HISTORIC AND DESIGN REVIEW COMMISSION

Agenda Item No: 21

HDRC CASE NO: 2015-182
ADDRESS: 130 GRAMERCY PL E
LEGAL DESCRIPTION: NCB 6381 BLK 1 LOT 31 32, 33, 34 & W 15 FT OF 35
ZONING: R5 H
CITY COUNCIL DIST.: 1
DISTRICT: Monte Vista Historic District
APPLICANT: Brad Westphall
OWNER: Cynthia Gonzaba
REQUEST:

Historic and Design Review Commission
Design Review Committee
Report & Recommendation

SIDE (WEST) ELEVATION

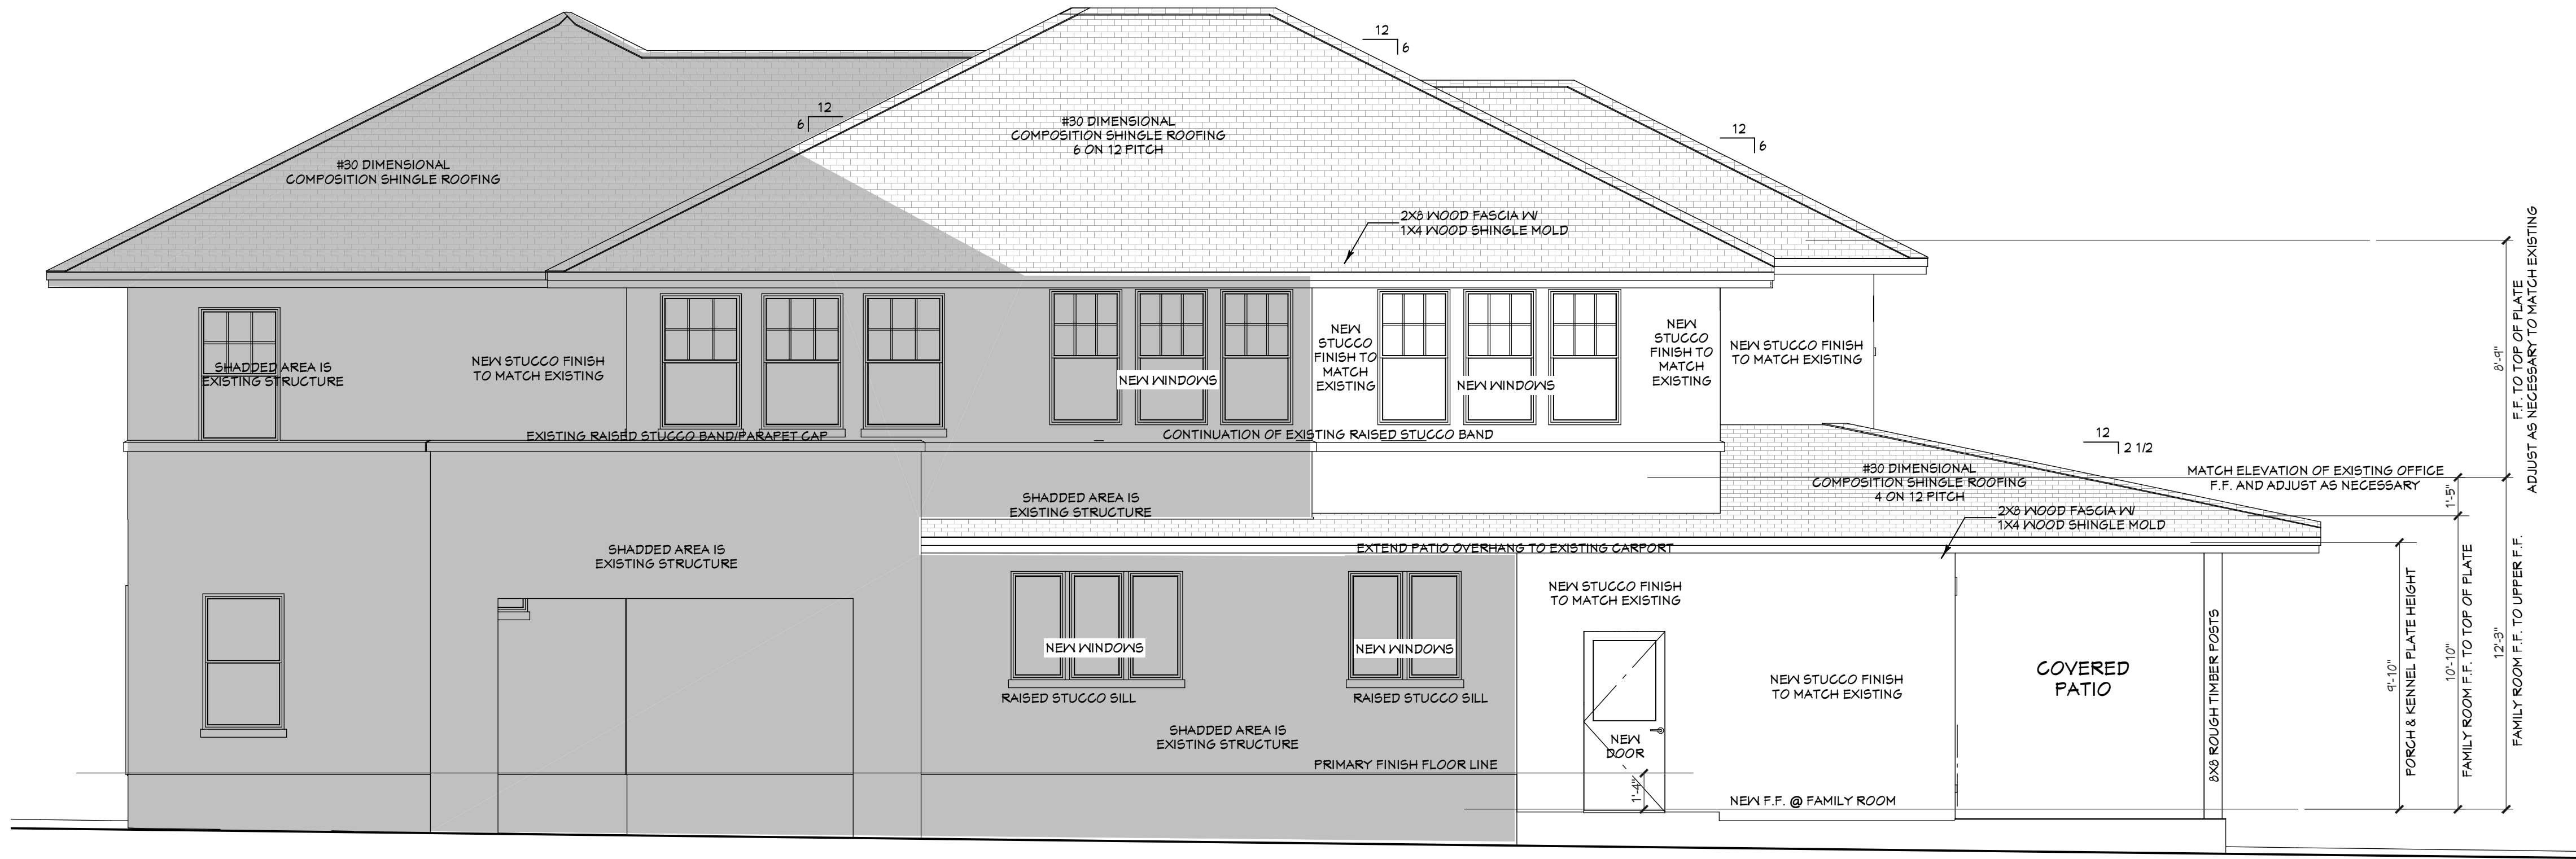
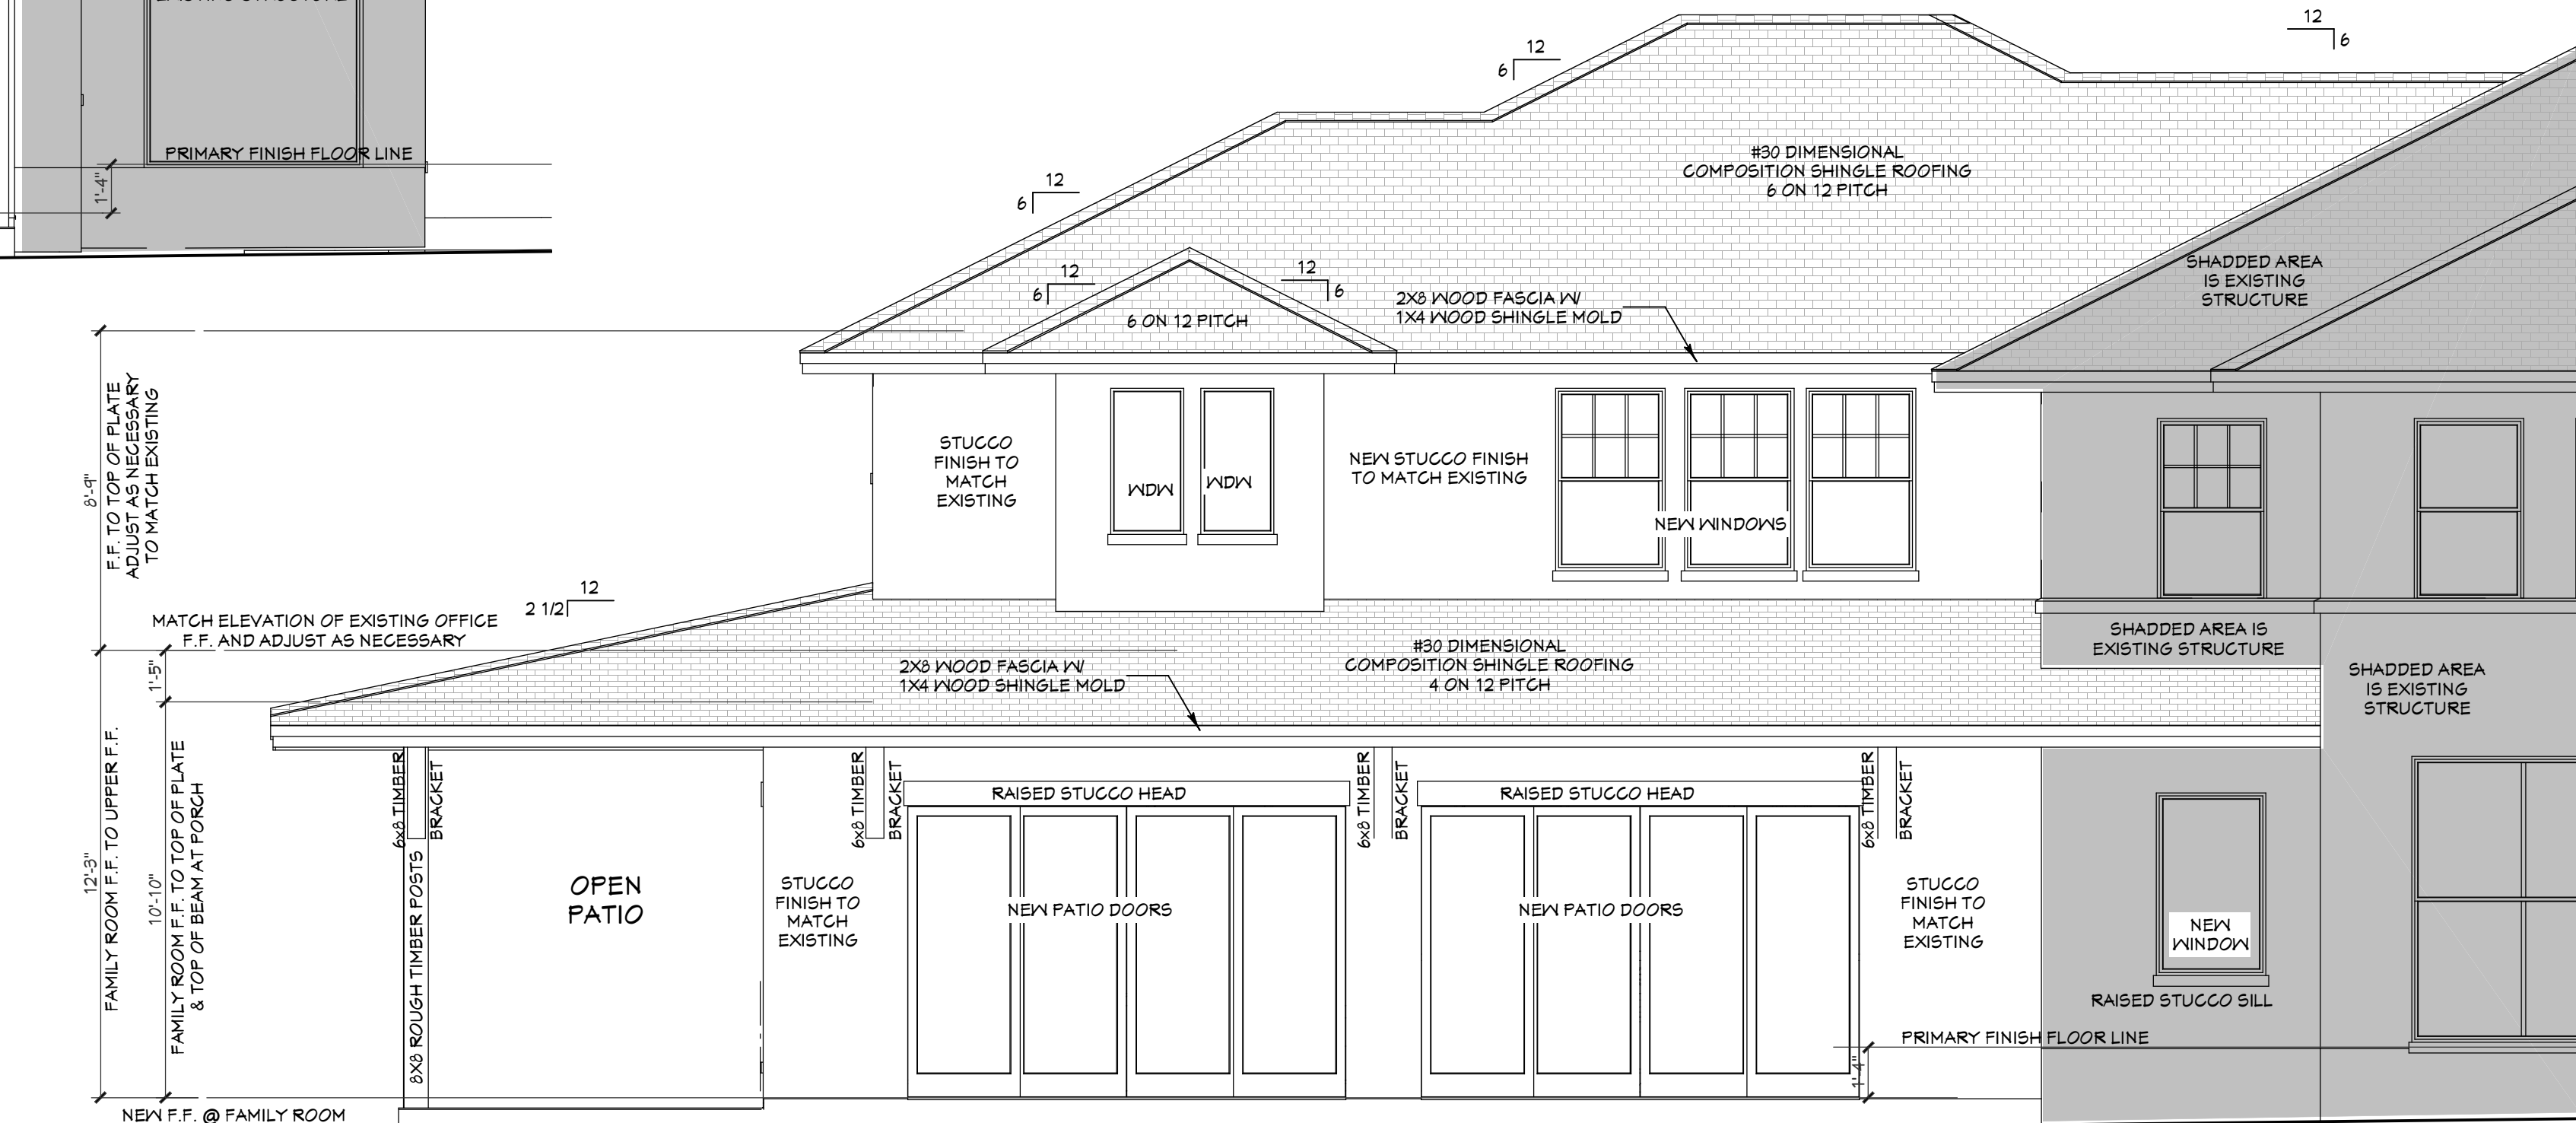
BF - Will roof be extended? DK - owner wanted tile
but roof load can't support it. AZ - roofing to match
arch. style. DK - owner wants fixed windows for
security. Addition is now set in 8". BW - second
issue was square windows which are now rectangular.
New windows will be aluminum clad wood.

BF - Always better to use wood, these are all new

THE ADDITION NEEDS MORE EXPRESSION, WOULD LIKE
TO SEE WOOD WINDOWS.

JL - Justify why you want aluminum clad vs. wood.
Especially since you don't have many windows.

REAR (SOUTH) ELEVATION

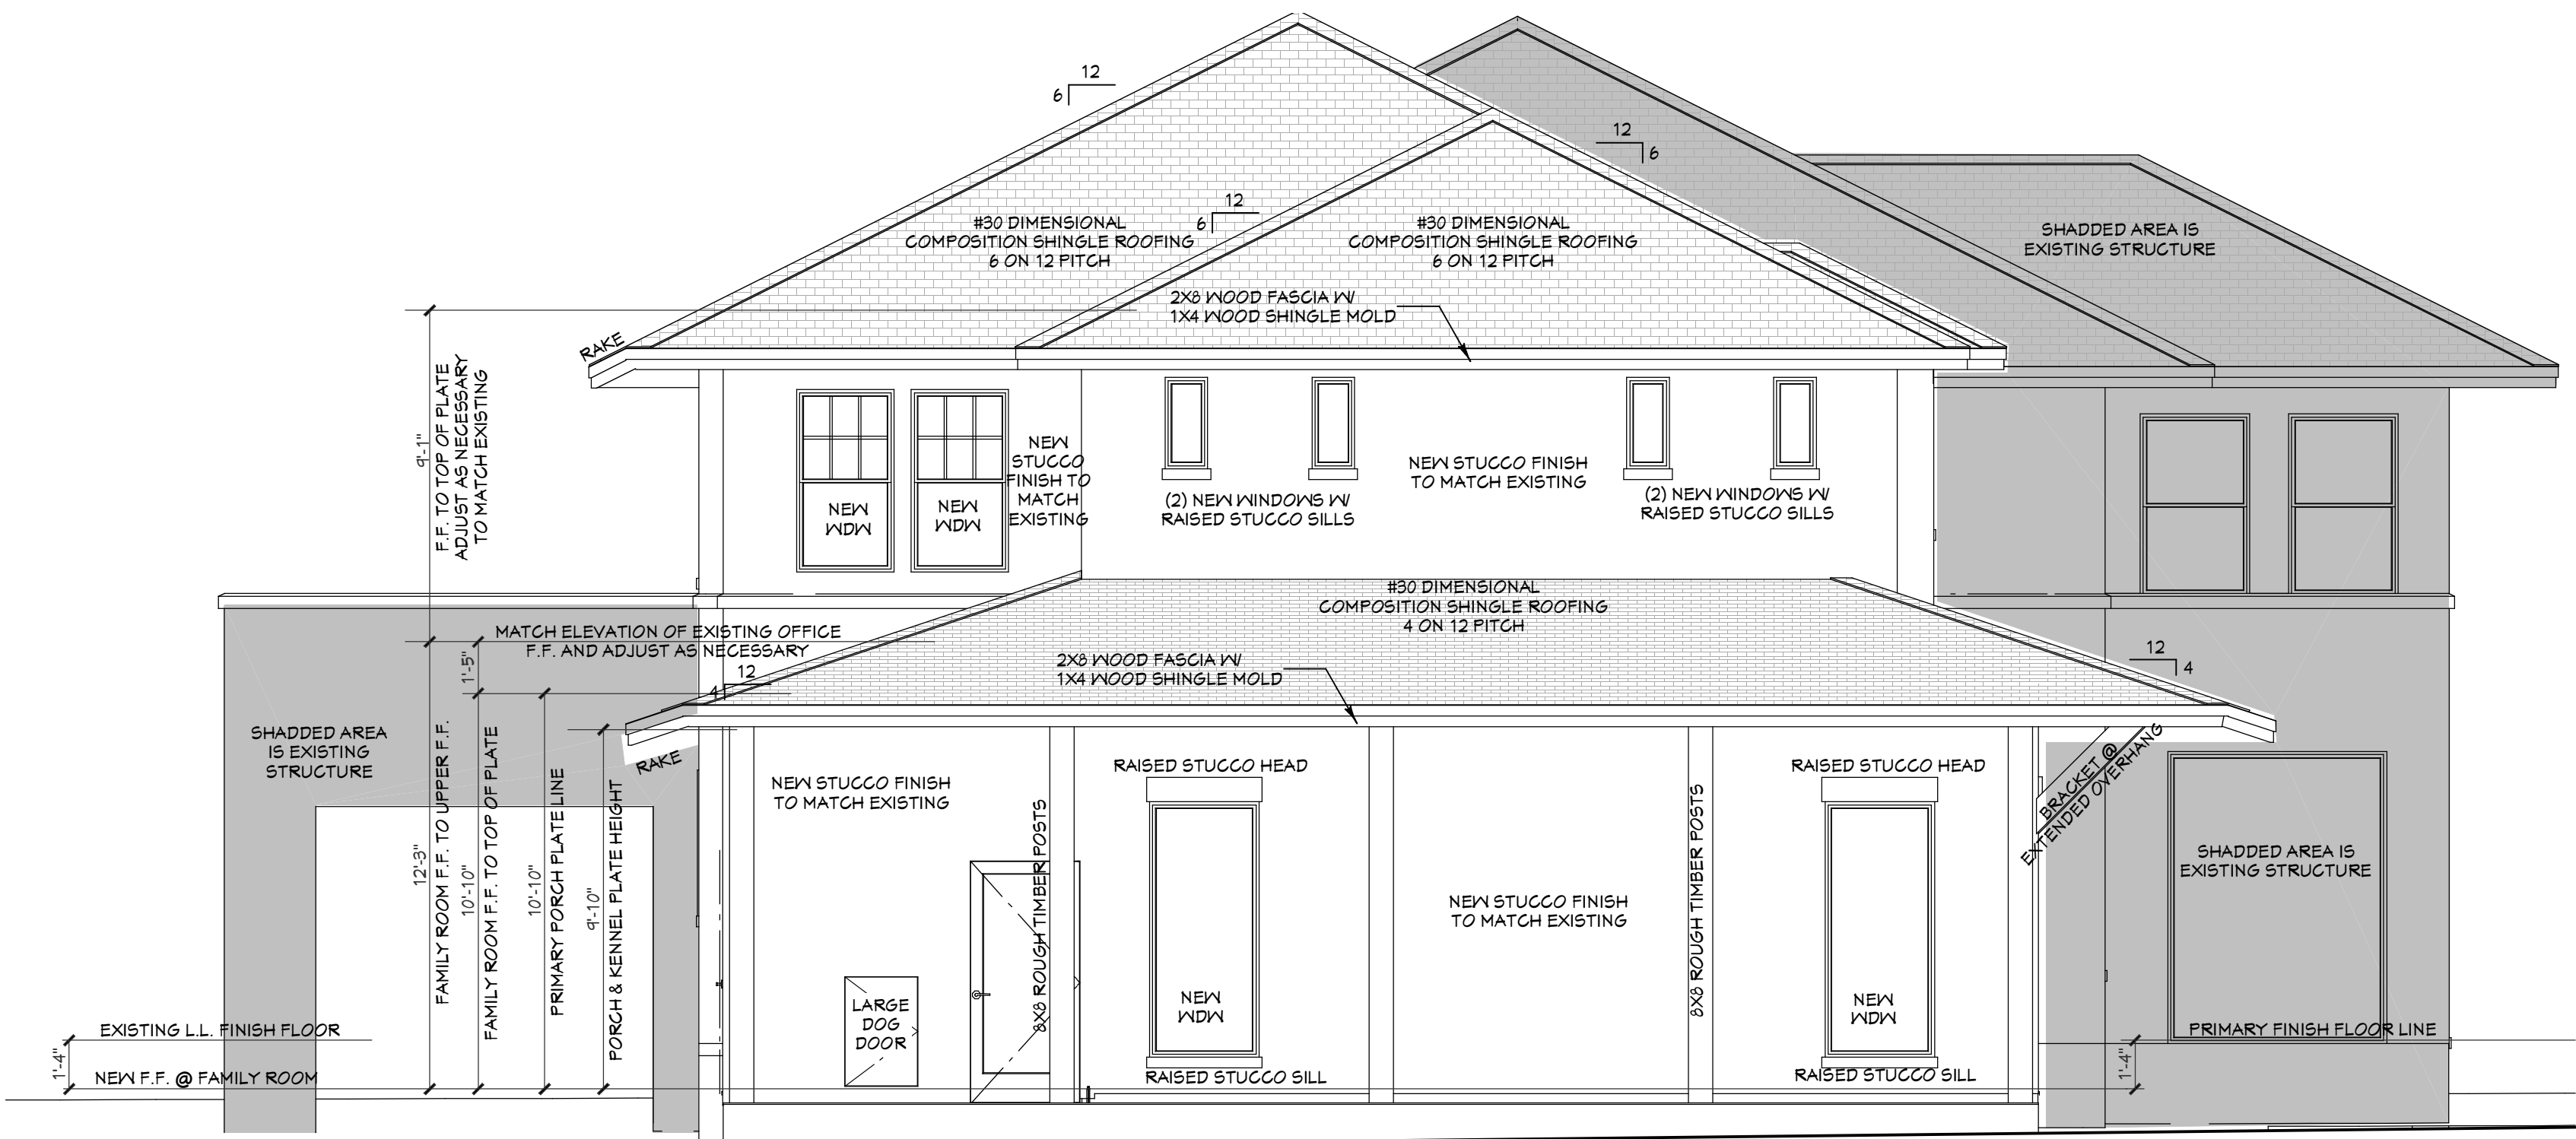
- h. According to the Guidelines for Additions, new additions should incorporate design elements such as the shapes of window and doors openings similar to the main structure. The proposed new windows will retain a rectangular shape similar in proportions to the windows on the main house which is consistent with the guidelines. However, double hung windows to match the windows on the house rather than fixed windows would be more appropriate.

- a. The new windows are double hung and not fixed
- b. New windows are one over one instead of six over one
- a. The fenestration pattern on the rear elevation is revised to be more consistent with the fenestration pattern on the main house
